# Proposed changes to the King Charles III England Coast Path in Suffolk at Corton and Dunwich Heath

Natural England's Variation Report to the Secretary of State

Coastal Access Variation Report VR21  
October 2024

**Map VR21e Dunwich Heath**

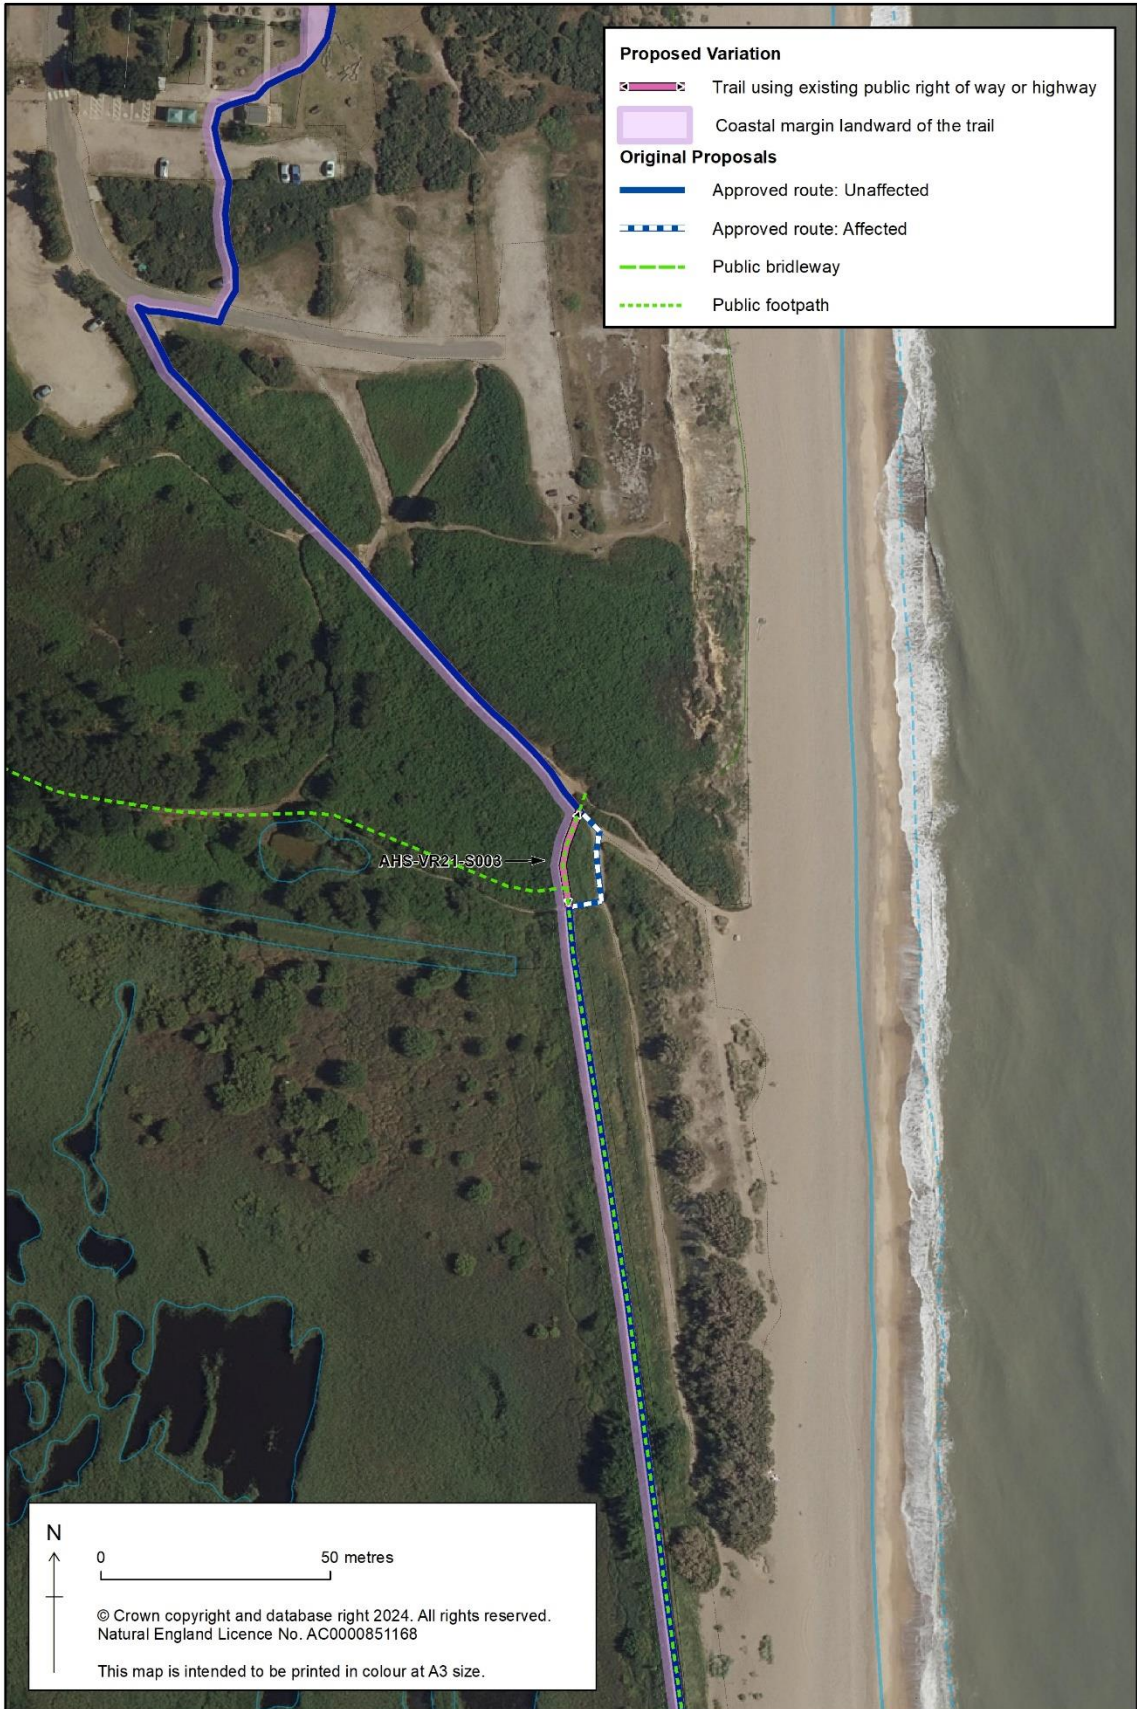
3.1.1 Sections AHS-2-S018 and AHS-2-S019 will be re-surfaced with stone aggregate as part of establishment works, and equipment/materials will be brought to site along a 22-metre length of public footpath that is currently unused because of vegetation growth. The works will require the clearance of the vegetation and it is proposed to then retain the cleared public footpath as the route variation, creating step-free access.

3.1.2 The approved alignment is on an existing walked route. See sections AHS-2-S020 to S022 (part) in Report 2. It starts on top of a low bank from AHS-2-S019 and continues onto a short set of steps off the seaward side of the bank onto AHS-2-S020. The ground surface is compacted shingle.

3.1.3 The varied route would be aligned onto 22 metres of a public footpath that is currently unused, and which continues in a straight line from AHS-2-S019, on top of the bank to join onto the rising ground of section AHS-2-S022. We anticipate that surface improvements to AHS-2-S019 would also continue onto the varied section.

3.1.4 The landowners support using the new route as the varied alignment, being a more direct and accessible route, which will be more intuitive for walkers. The landowners would remove the set of steps.

- is formed of 22m of public footpath that is available after clearance of vegetation.
- extends northward at a maximum of 8 metres west of the approved route and is on higher ground.

- would be improved to a compacted two metre wide fine-graded aggregate surface
- would be on level ground
- improves accessibility by not using a set of steps down the side of the bank which is included on the approved alignment.

**Map VR21f Dunwich Heath - Key Statutory Environmental Designations**

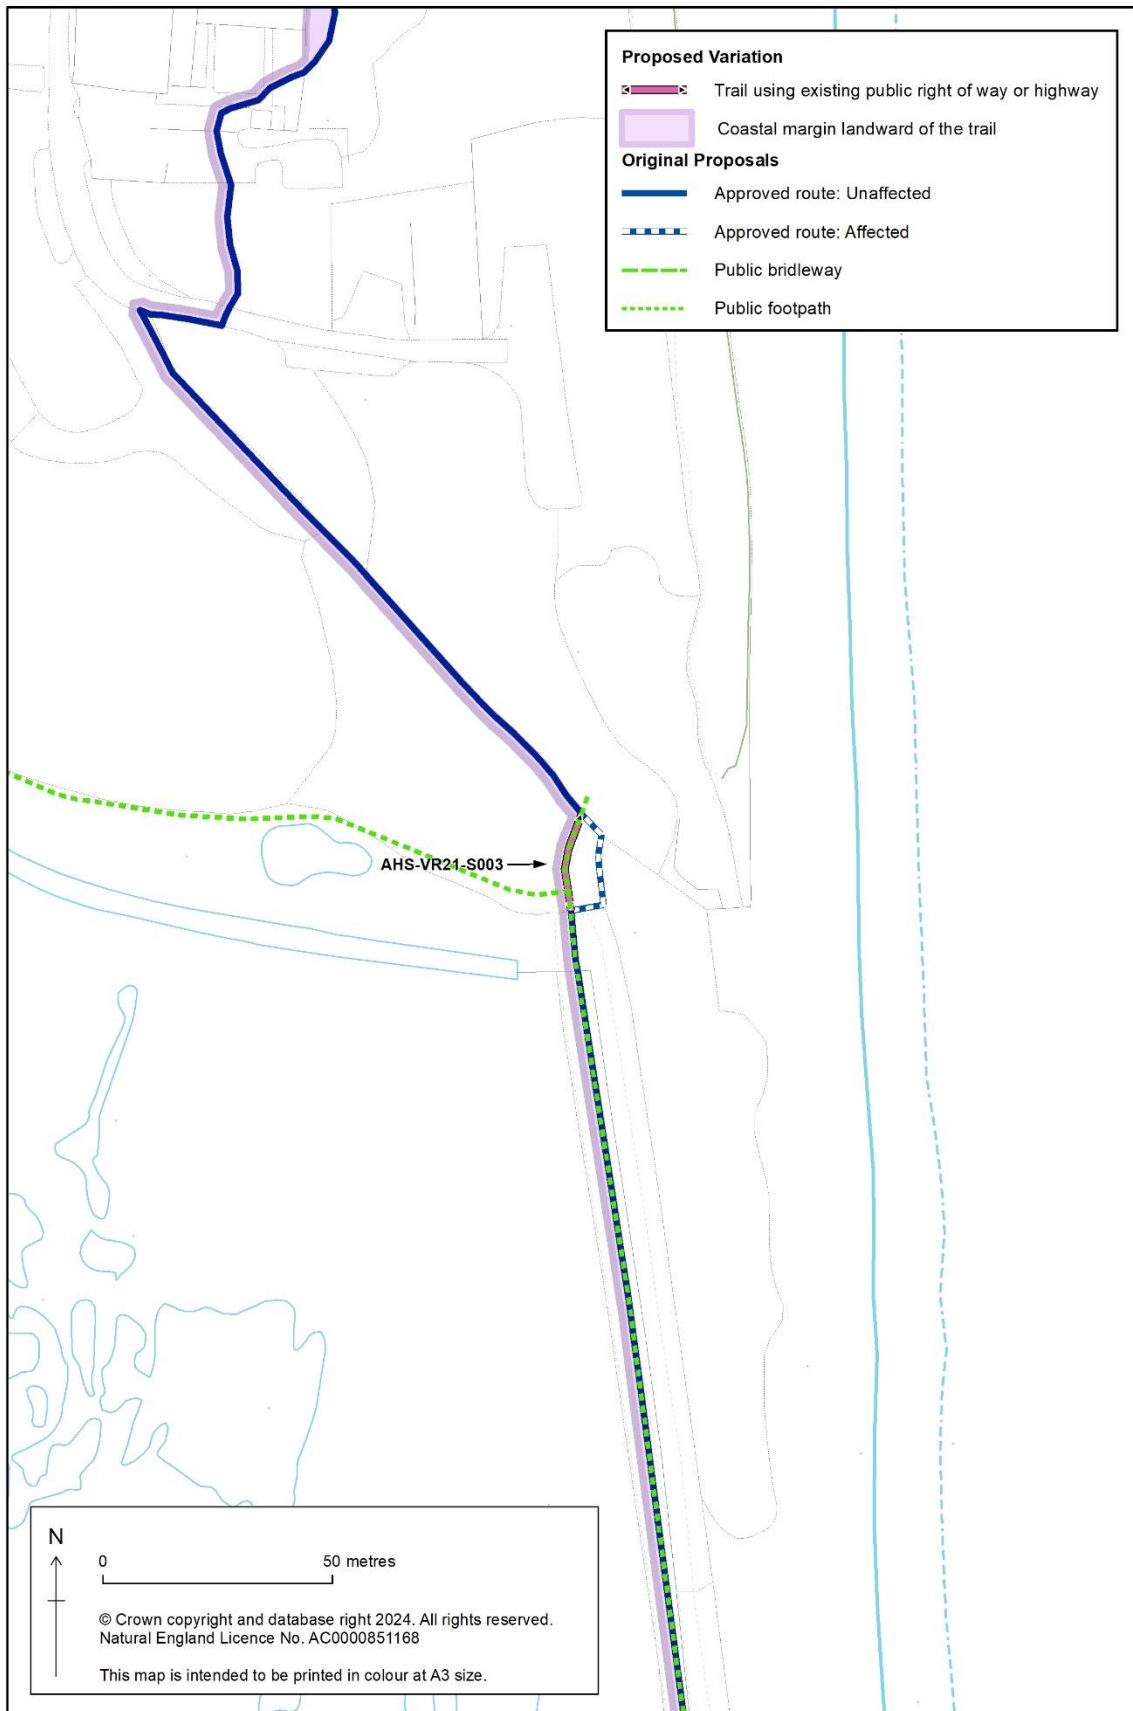
3.2.3 The section of trail affected by this variation passes through an area of lowland heathland, that has developed young scrub over a public right of way.

3.2.4 The following designated sites are within the limits of this variation proposal:

- Minsmere-Walberswick Heaths and Marshes SSSI
- Minsmere to Walberswick Heaths & Marshes SAC
- Minsmere-Walberswick Ramsar
- Minsmere-Walberswick (SPA)

Map VR21f Key Statutory Environmental Designations - shows the extent of these designated sites in relation to the proposal.
